GENERAC[®]

PRODUCT INFORMATION BULLETIN

SUBJECT: 7.4L Flange, Flex Drive Coupling Replacement

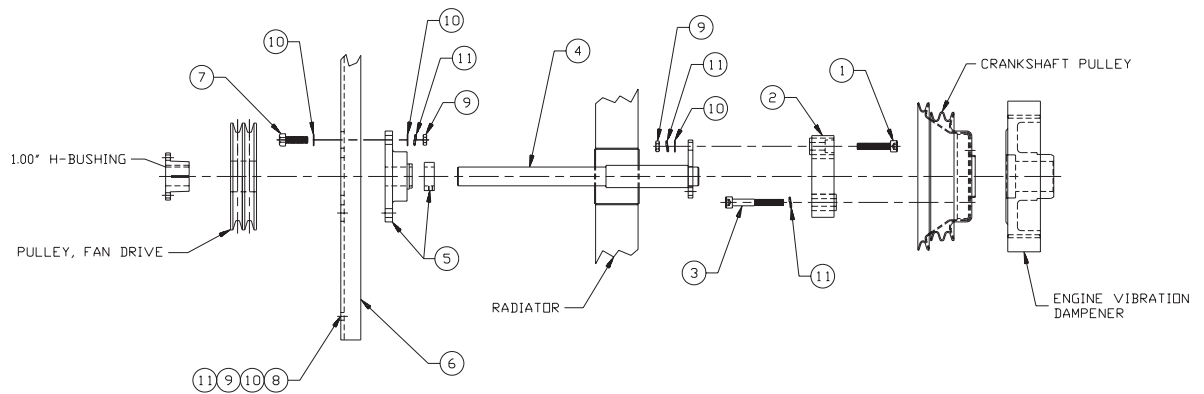
MODELS AFFECTED: 85 & 100 kW gearbox driven units with 7.4L engines (pre April 2001).

CORRECTIVE ACTION: When replacing the coupling assembly use kit number #**D4328**. This kit should be used on product built prior to April 2001.

<u>ITEM</u>	<u>QTY.</u>	<u>DESCRIPTION</u>
1	3	SCREW SHC 3/8-16 X 1.75 G8.8 NZ
2	1	COUPLING FAN DRIVE
3	3	SCREW SHC 3/8-24 X 2.75 G8.8 NZ
4	1	ASSEMBLY FAN DRIVE
5	1	FLANGE BEARING Ø1.00
6	1	FAN SUPPORT ASSEMBLY
7	1	SCREW HHC 3/8-16 X 1-1/4" G5
8	4	SCREW HHC 3/8-16 X 1 G5
9	9	HEX NUT 3/8-16 STEEL
10	9	WASHER FLAT 3/8-M10 ZINC
11	12	WASHER LOCK 3/8"

SUBJECT: GV410 Starters

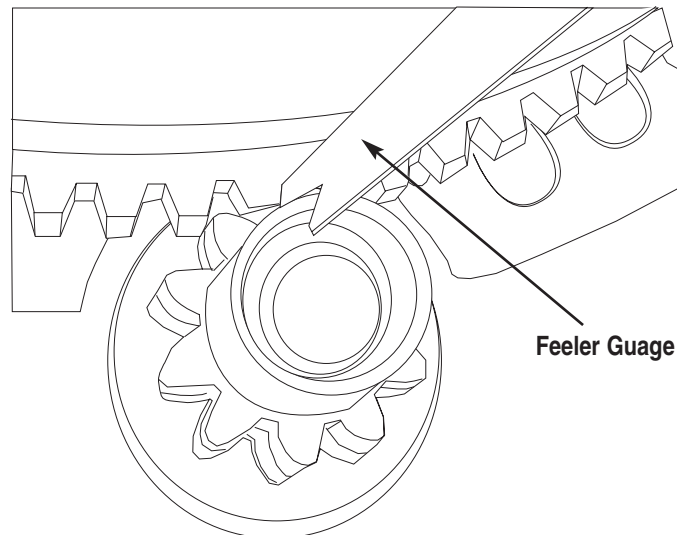
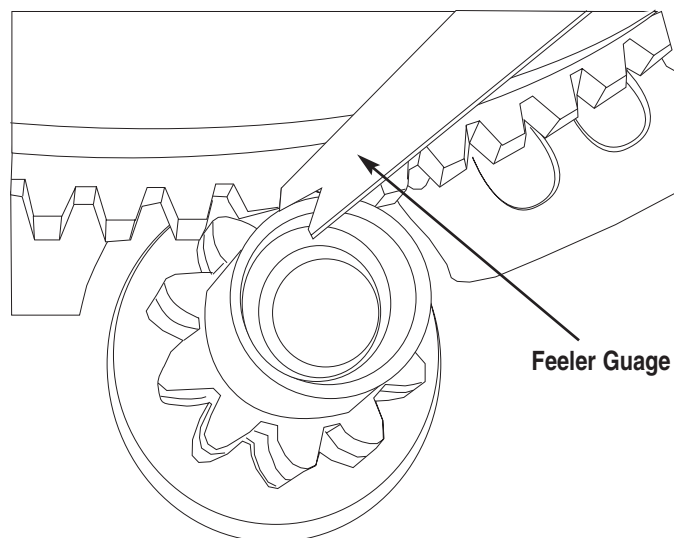
PROBLEM: Starter pinion jammed into flywheel on initial cranking.

CORRECTIVE ACTION: Measure the voltage at the terminal of the starter contactor and verify 11-12 volts DC is available to the generator during cranking. If voltage is below 11 volts DC, measure at the battery terminals during cranking. If battery voltage is below 11 volts DC, recharge/replace battery. If battery voltage is above 11 volts DC, check for proper battery cable sizing, see owners manual.

Manually engage the starter pinion into to ring gear on the flywheel and check for .020-.035 inch backlash. When checking backlash, measure at eight equally spaced locations and make sure the gear teeth are in contact in the direction of rotation. Shim or remove shims as necessary, use shim kit part number OD4791. Visually check that the starter motor is perpendicular to the ring gear. Replace the starter motor if the starter motor mounting bracket is bent.

Check for proper position of rectangular rubber bumper part number 0C3794. Older units used rubber dimples, they should be replaced if jamming is occurring. New rubber bumper gets placed at base of block right above sump cover, and on the centerline of the starter.

SUBJECT: Blocking Plugs on the C Option PCB Connector

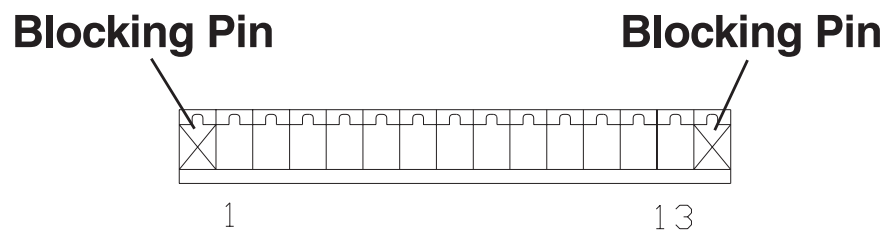
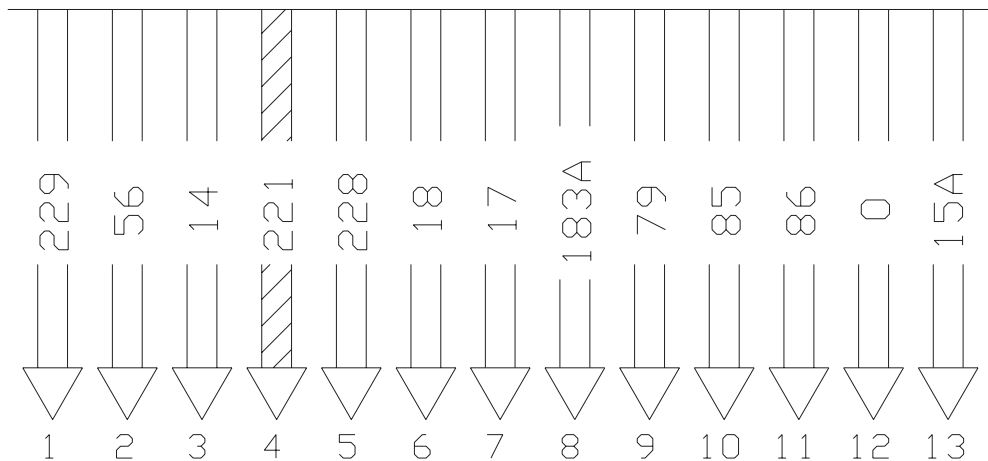
PROBLEM: The J2 plug that connects to the #083089 C Option PCB may have the Blocking Pins (or Keys/Plugs) missing from the ends of the plug. The Blocking Pins prevent the connector plug from being misaligned with the PCB pins.

CORRECTIVE ACTION: Take care when removing and reinstalling the connector. Make sure the pins are properly aligned. When properly aligned, there will be an empty plug on each end. The part number for the Blocking Pin is #078696.
